TMDXEVM6678L EVM Known issues

2. TMDXEVM6678L EVM Design Enhancements

2.1 Unexpected EVM Reset Event on the Beta1 EVMs

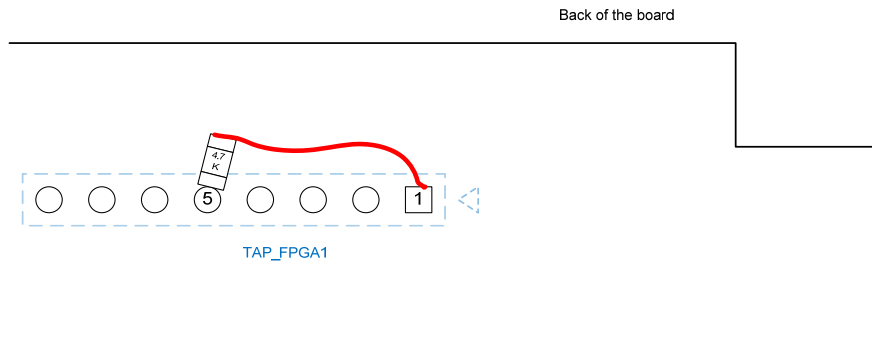
All Beta1 EVMs have a design erratum that may need to be corrected. The TDI input to the FPGA is floating. This has been observed to allow unexpected FPGA behavior on a small percentage of the boards. Often, the SYSPG_D1 LED goes out and CCS unexpectedly disconnects. A pull-up resistor needs to be added to prevent this from happening. This can be added on the bottom of connector TAP_FPGA1 between pins 1 and 5. Any resistor value between 1K and 10K will suffice. The following figure shows this rework.

2.2 Incorrect pin out on the HyperLink1 connector on The EVMs

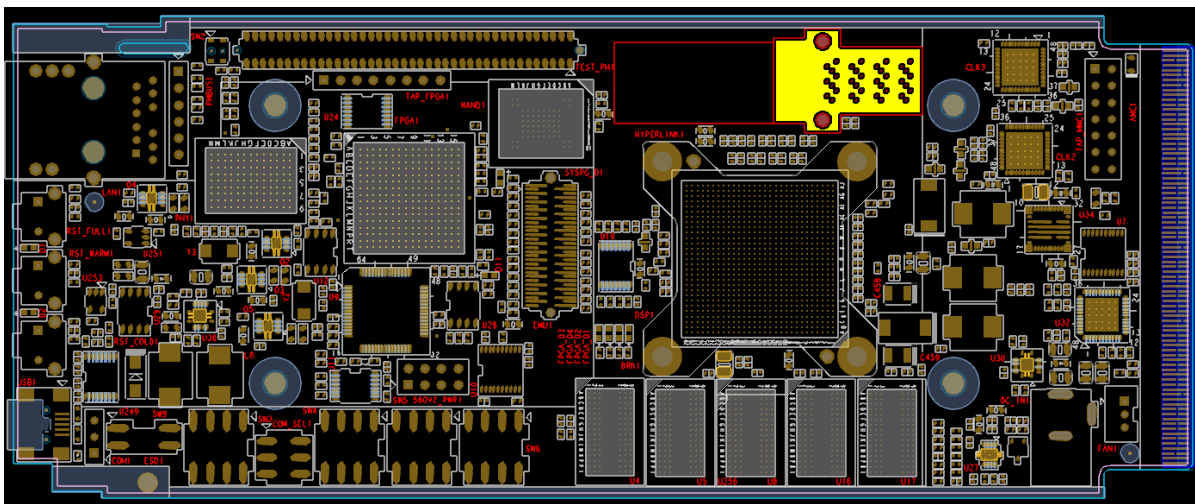
All Beta1 EVMs had populated the iPass+HD mini-SAS connector on the HyperLink1 for the HyperLink connection. The pin out on the HyperLink1 is incorrect, most signals will be shorted if connecting the HyperLink interface by the cable. The HyperLink1 can NOT be used and is not installed on Beta1 and Beta2 EVMs.
